Pitt Street North Over Station Development Modification 1

Design amendments and clarifications
State Significant Development Modification Assessment
(SSD 10375 MOD 1)

July 2022

Figure 3 | Proposed northern elevation (left) compared to approved northern elevation (right) (Source: Modification Report)

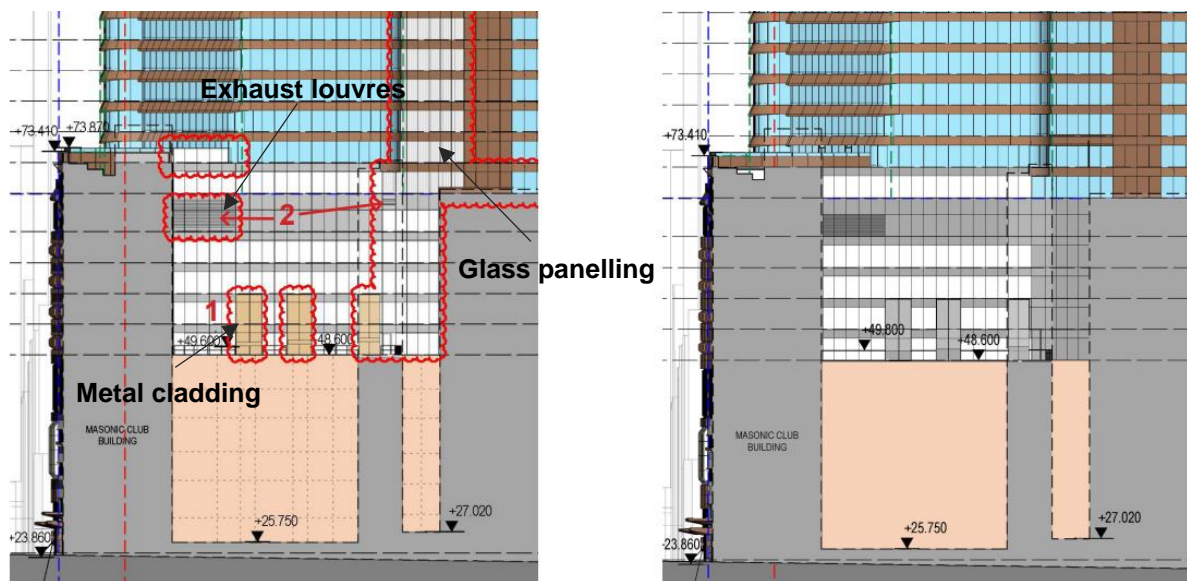
Modifications	Findings	Recommendations
Facade Materiality	<ul style="list-style-type: none"> • The modification application seeks to change the material and finishes of the northern elevation, including the use of fluted glazing in lieu of a glass curtain wall adjacent to the amenities and replacement of white spandrel glazing with metal cladding (Figure 3). • The Applicant notes the proposed amendments include clarification of the materials due to inconsistency in the approved plans, as well as minor material changes to improve constructability. • The Department acknowledges the proposed materials integrate well with the materials approved for the same facades within the 'Metro Station Box'. • The Department supports the changes as it has minimal impact on the public domain or 	Condition A2 has been updated to reflect the amended architectural drawings.

Exhaust louvres	<ul style="list-style-type: none">• The proposal seeks to enlarge the approved exhaust louvres on the northern elevation of the podium to match the mechanical intake / exhaust layout (Figure 3).• The Department notes Condition F11 ensures the operation of plant and equipment shall not give rise to an 'offensive noise' as defined in the <i>Protection of the Environment Operations Act 1997</i> and Regulation.• The Department supports the proposed changes as Condition F11 ensures the development does not impact on the amenity of adjoining development.	Condition A2 has been updated to reflect the amended architectural drawings.
Architectural clarification	<ul style="list-style-type: none">• The proposal seeks to clarify the corrugation detailing on the eastern and western elevations of the podium (Figure 5).• The Department notes the corrugated detailing was omitted from the approved drawings, however, was shown in all renders and supporting design reports.• The Department supports the proposed clarifications.	Condition A2 has been updated to reflect the amended architectural drawings.

Figure 5 | Additional detailing clarifying the extent of corrugated details on the eastern and western elevations (Source: Modification Report)

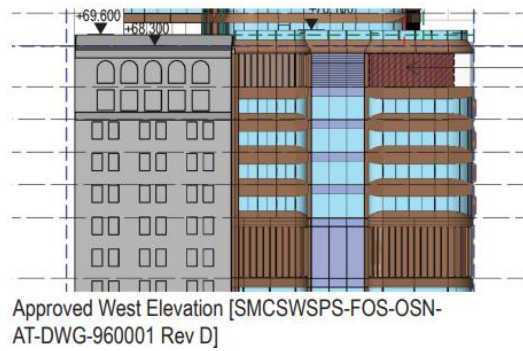
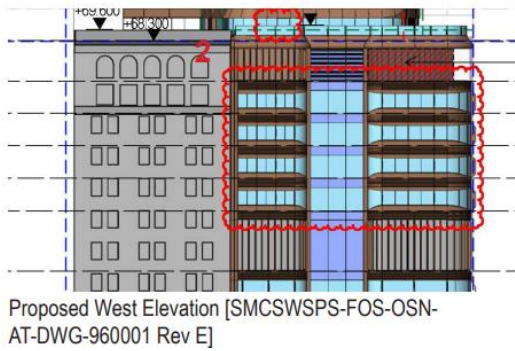
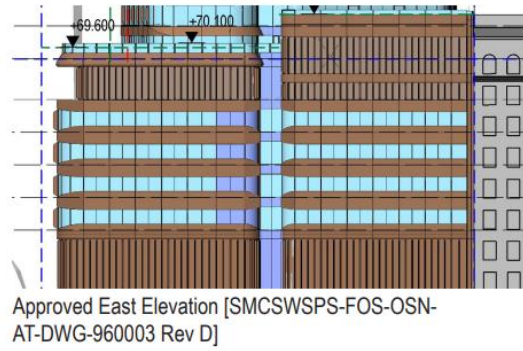
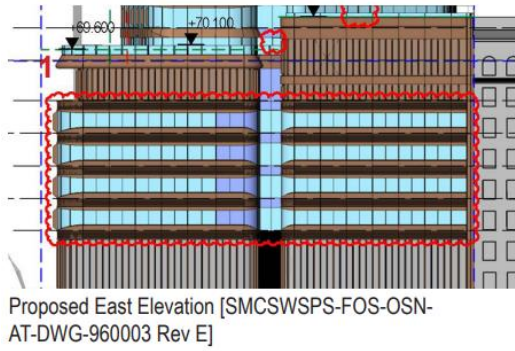
- changes to the opacity of glass panels, clarification of metal cladding and enlargement of the mechanical exhaust louvres on the northern elevation
- clarifying the extent of corrugation details on the eastern and western elevations
- changes to the terrace doors on level 10 and level 11 from single width swing doors to sliding doors
- internal changes to approved plant rooms.

Figure 7 | Proposed additional elevation plan (Source: Modification Report)

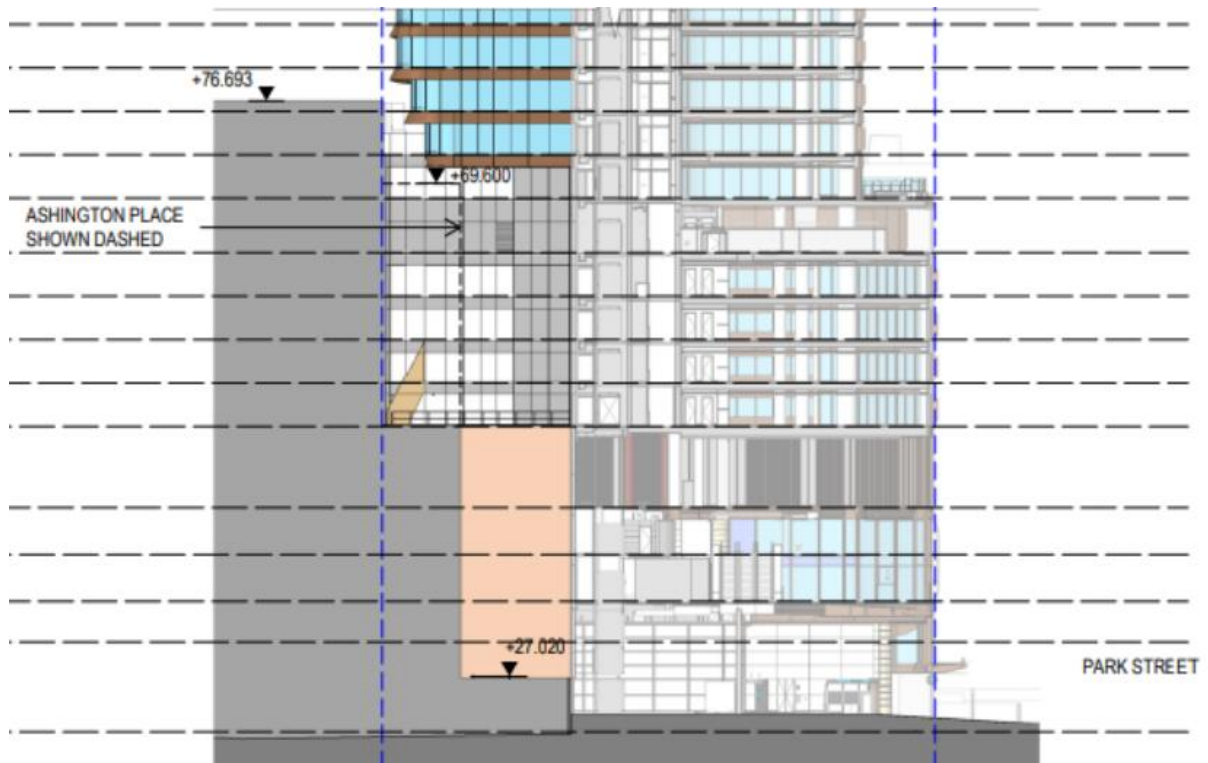
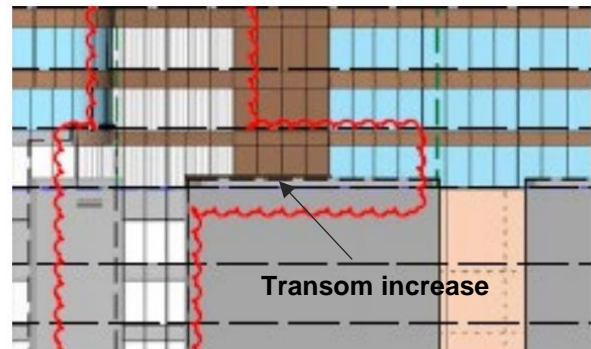
Additional plans	<ul style="list-style-type: none"> • The Applicant notes the north-west podium elevation was obscured in the approved General Arrangement Elevation West Elevation - Pitt Street Plan. The Applicant proposes to include an additional plan, titled General Arrangement Elevation West Elevation - North South Section (Figure 7) to illustrate secondary western facade obscured in the original approval. • The Department supports the additional plan as it provides clarity to the materials and finishes of the section of building obscured in the original approval. 	Condition A2 has been updated to reflect the amended architectural drawings.
Level 10 transom	<ul style="list-style-type: none"> • The modification application seeks to increase the height of the level 10 transom on the northern elevation (Figure 8). • The Applicant notes the proposed change is required to allow for adequate waterproofing structures between the adjoining building, Ashington Place. • The Department the proposed modification. 	Condition A2 has been updated to reflect the amended architectural drawings.
